TOWN OF NEWBURGH PLANNING BOARD TECHNICAL REVIEW COMMENTS

PROJECT NAME: CROSSROADS CONSTRUCTION MANAGEMENT-SUBDIVISION

PROJECT NO.: 22-15

REVIEW DATE: 30 SEPTEMBER 2022 MEETING DATE: 6 OCTOBER 2022

EERING MYEYING MEYING M	ONTGOMERY OFFICE 71 CLINTON STREET ONTGOMERY, NY 12549 Ph: (845) 457-7727 WWW.EP-PC.COM
OVERALL	& SUBDIVIS	SION PLANS
тс	CONSTRUCTION 8 UNION AVENU OWN OF NEWB GE COUNTY, N	URGH
#:	DRAWN BY:	
1325.04	RMB	0 101
04/04/22	SCALE: AS NOTED	C-101
SION:	TAY LOT.

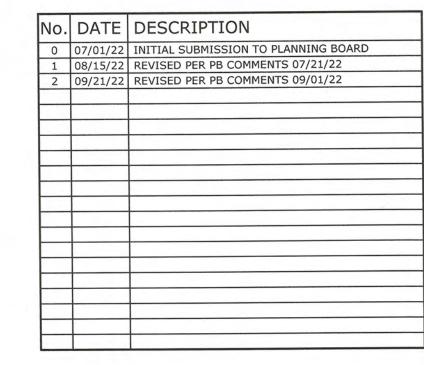
- 3. Coverage under the NYSDEC Construction Stormwater Program must be obtained. This office will process a Municipal Authorization form upon request.
- 4. Note 12 on the plans should be modified to state that the As Built Plan certification shall be submitted to the Building Department prior to issuance of Certificate of Occupancy on any individual lot.

- 1. This office respectfully requests that the driveway access and maintenance agreement be conditions of final approval.
- 2. Per the Planning Board engineer, the Highway Superintendent takes no exception to the proposed driveway locations.
- 3. No response required.
- 4. This office respectfully requests that coverage under the NYSDEC Stormwater Program be a condition of final approval.
- 5. This office respectfully requests that a Public Hearing be scheduled for the October 6, 2022, Planning Board meeting.
- 6. The Town of Newburgh Water System notes have been included on Sheet C-301 of the site plan.
- 7. General Note #12 on Sheet C-101 states that an as-built plan and certification by a NYS Design Professional shall be provided to certify that the construction of the septic system is consistent with the approved plans.

- 9. DUE TO THE PROXIMITY OF THE PROJECT SITE TO KNOWN INDIANA BAT HIBERNACULUM, POTENTIAL ROOST TREES SHALL ONLY BE CUT AND REMOVED DURING KNOWN HIBERNATION MONTHS BETWEEN THE DATES OF OCTOBER 1ST THROUGH MARCH 31ST, IN ORDER TO AVOID DIRECT ADVERSE IMPACTS TO THE
- 10. CONTRACTOR TO FIELD LOCATE EXISTING WATER MAIN PRIOR TO INSTALLATION OF PROPOSED WATER SERVICE LINE.
- 11. A PLOT PLAN MUST BE SUBMITTED FOR EACH LOT AND THE PROPOSED STRUCTURES STAKED OUT IN THE FIELD PRIOR TO ISSUANCE OF A BUILDING
- 12. AN AS-BUILT PLAN AND CERTIFICATION BY A NYS DESIGN PROFESSIONAL SHALL BE PROVIDED TO CERTIFY THAT THE CONSTRUCTION OF THE SEPTIC SYSTEM IS CONSISTENT WITH THE APPROVED PLANS.
